CITY OF CARMEL-BY-THE-SEA HISTORIC RESOURCES BOARD AGENDA

- 3) **DS 25240 (Ramos):** Consideration of a Determination of Consistency with the Secretary of the Interior's Standards for Design Study application, DS 25240 (Ramos), for after-the-fact revisions to a previous

TO: Historic Resources Board Members
SUBMITTED BY: Katherine Wallace, Associate Planner
SUBJECT: **DS 25240 (Ramos):** Consideration of a Determination of Consistency with the Secretary of the Interior's Standards for Design Study application, DS 25240 (Ramos), for after-the-fact revisions to a previous approval (DS 23396) that include the removal of roof shingles, horizontal wood siding, wood shingle siding, wood windows, and a Carmel stone chimney, replaced with new at the historic "Rockwell House" located on the northeast corner of San Antonio and 12th Avenues in the Single-Family Residential (R-1) Zoning District and the Beach and Riparian Overlay District. APN 010-279-008-000

SCALE: 1/4" = 1'-0"

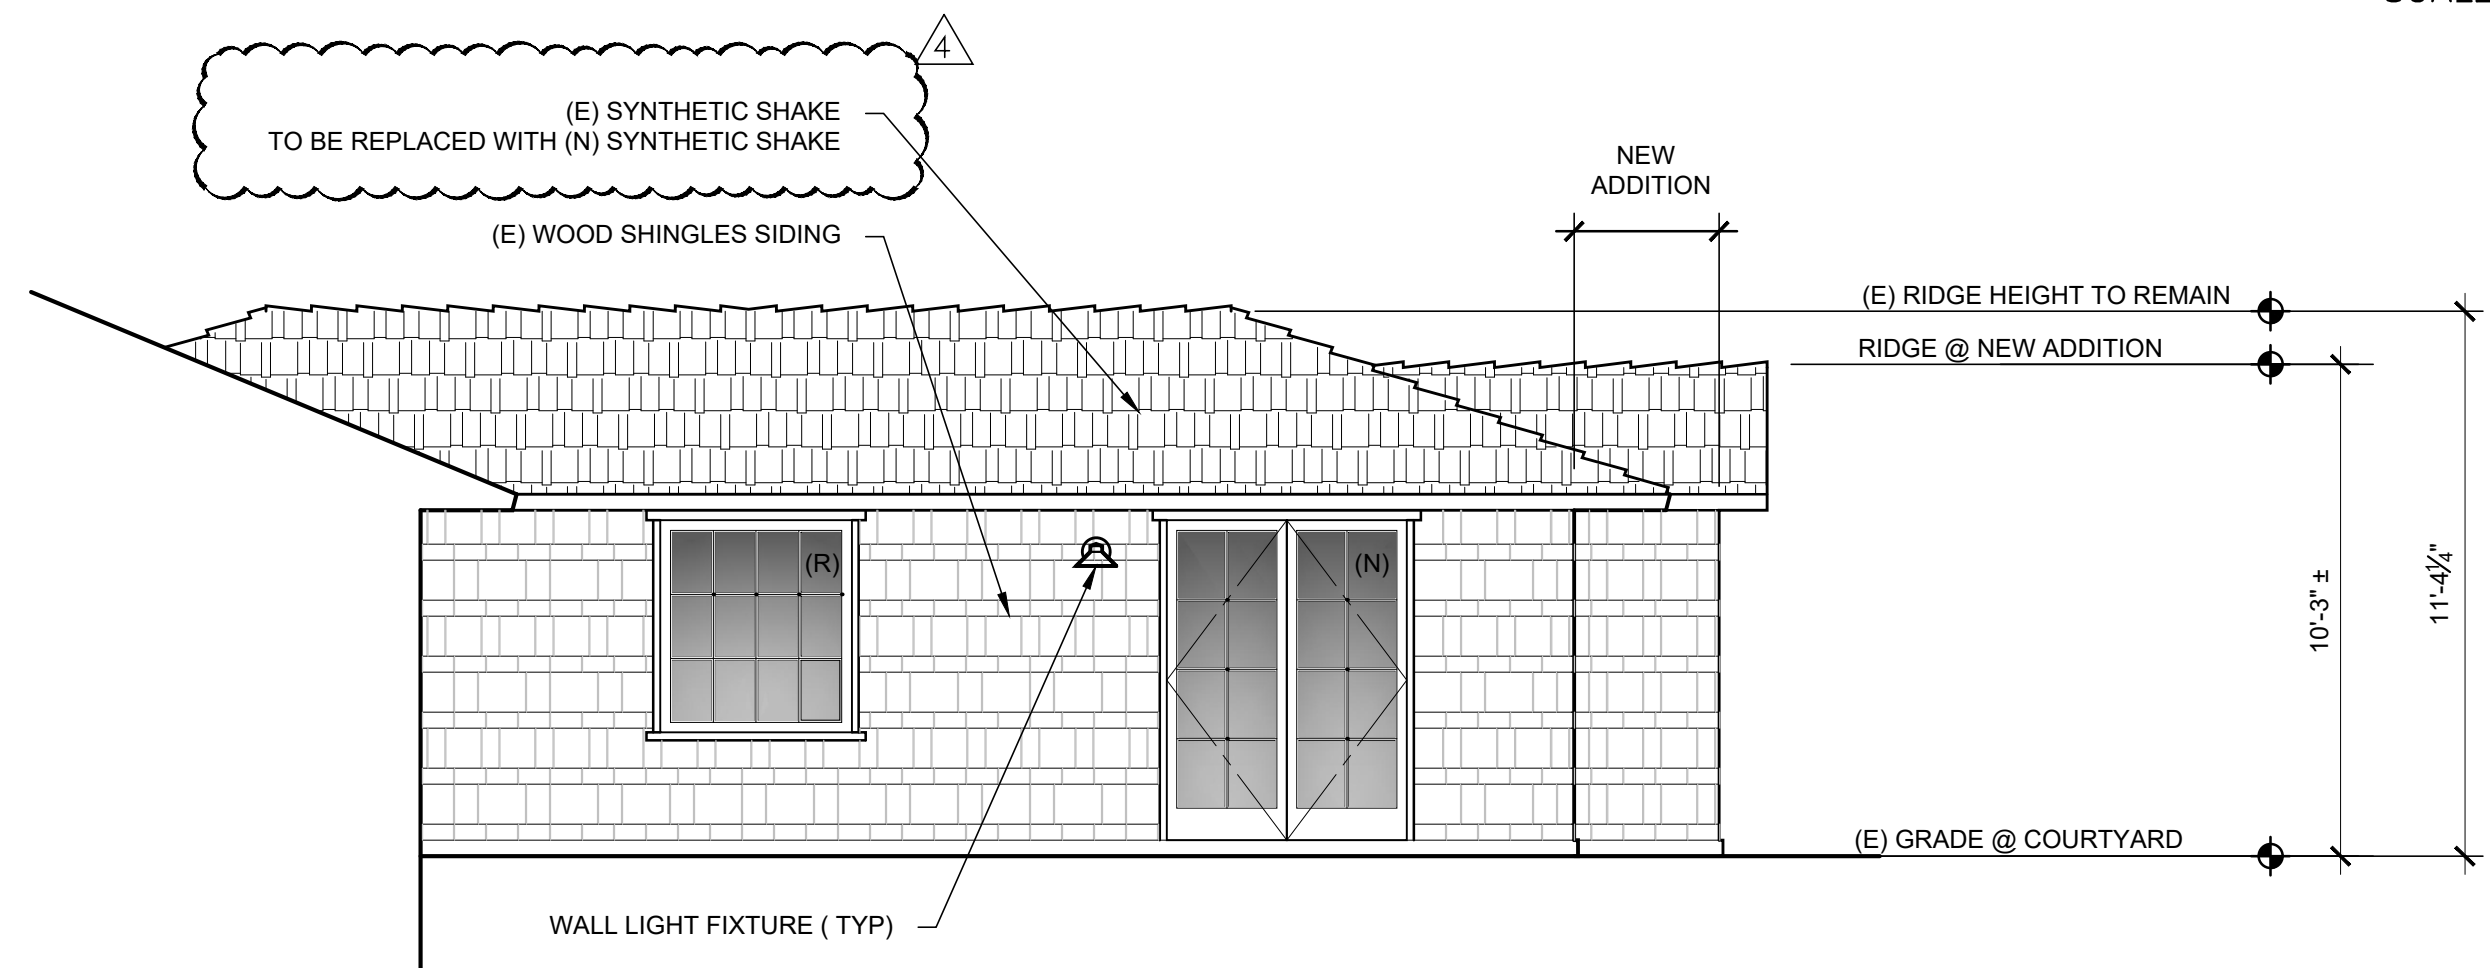
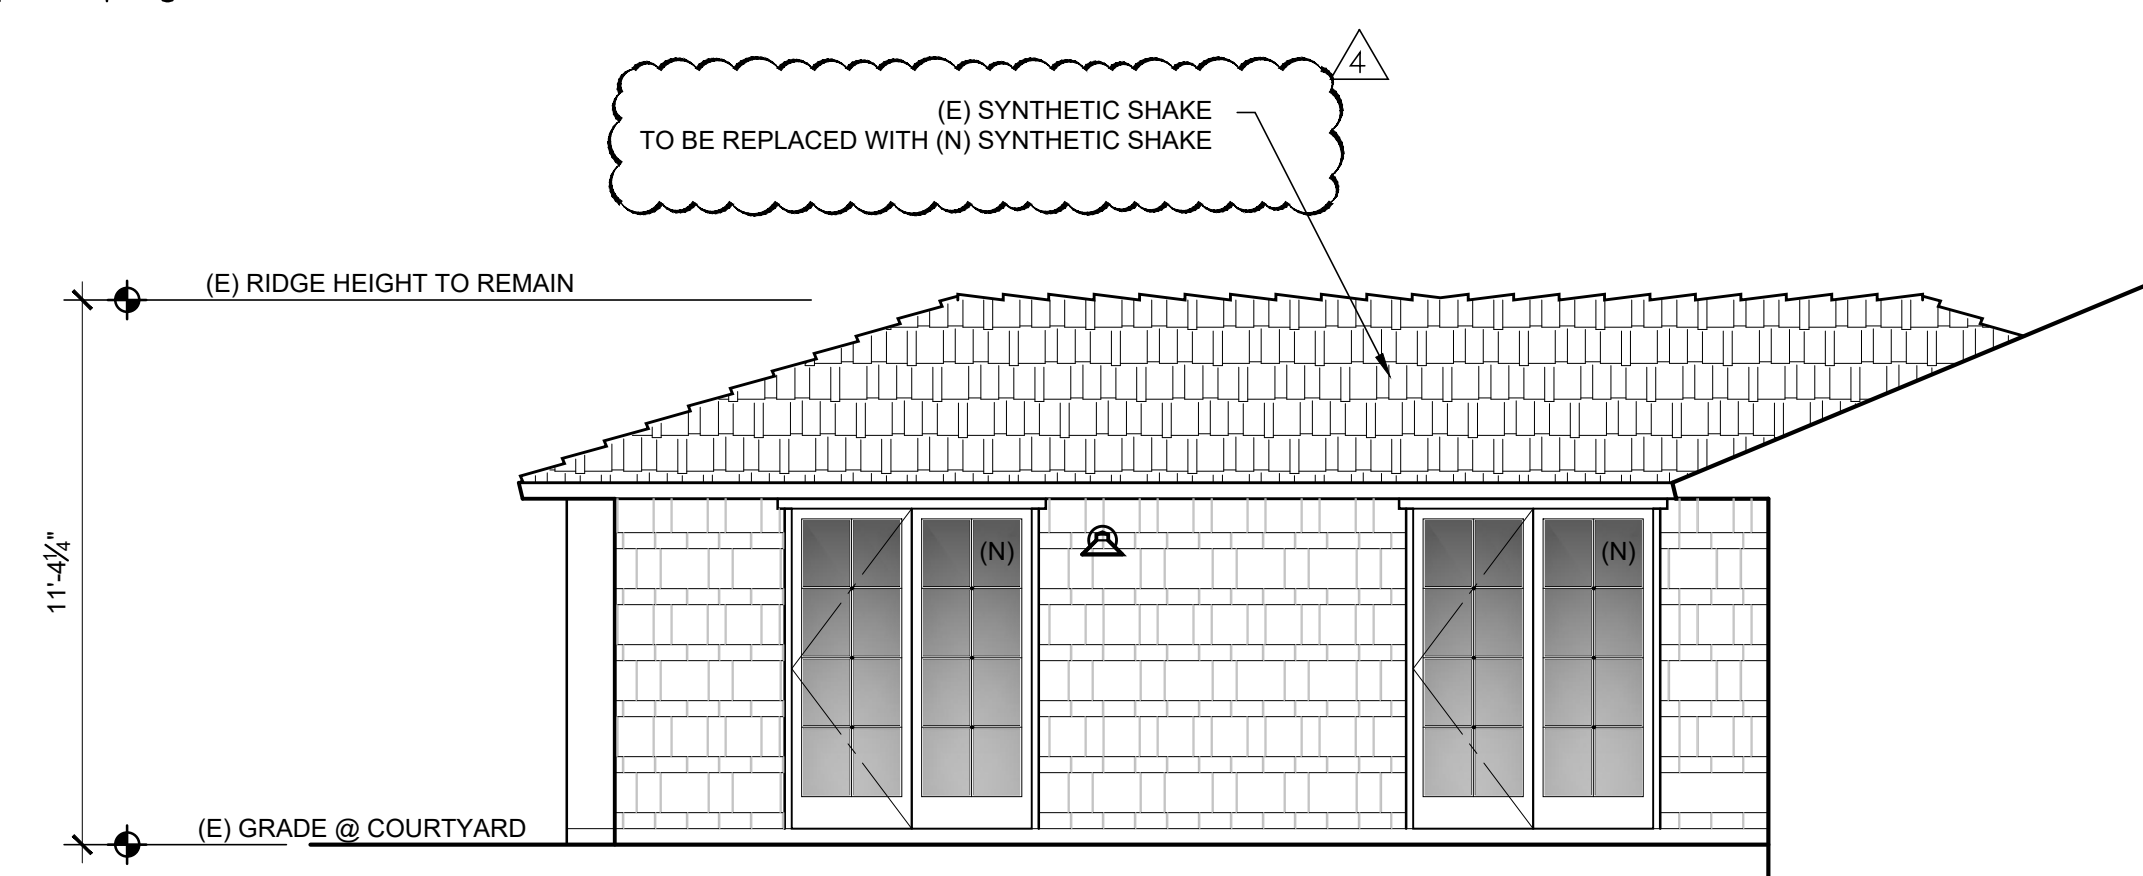
To be consistent with Standard Nine, any new siding used in the additions should be differentiated from the existing siding, so the additions are clearly discernable from the historic house. However, the shingles on the additions currently match the original "ribbon course" pattern used in the historic house (see Figure 6).³ To differentiate the shingles on the additions, the architect and contractor have suggested removing 5/8" from selected shingles along the shingle course in the additions to create a staggered pattern (see Plan Sheet A3.1). This solution will differentiate the old from the new materials and meet the requirements of Standard Nine.

Based on the recommendations of the qualified professional, Margaret Clovis, the after-the-fact project components are consistent with the Secretary of the Interior's Standards for the Treatment of Historic Properties, except for the new chimney and the non-differentiated wood shingles on the additions. As such, staff recommends the Board incorporate condition of approvals as part of the determination. The conditions shall require that prior to approval of the Design Study (DS 25240), the owner/applicant shall submit modified plans to staff that demonstrate:
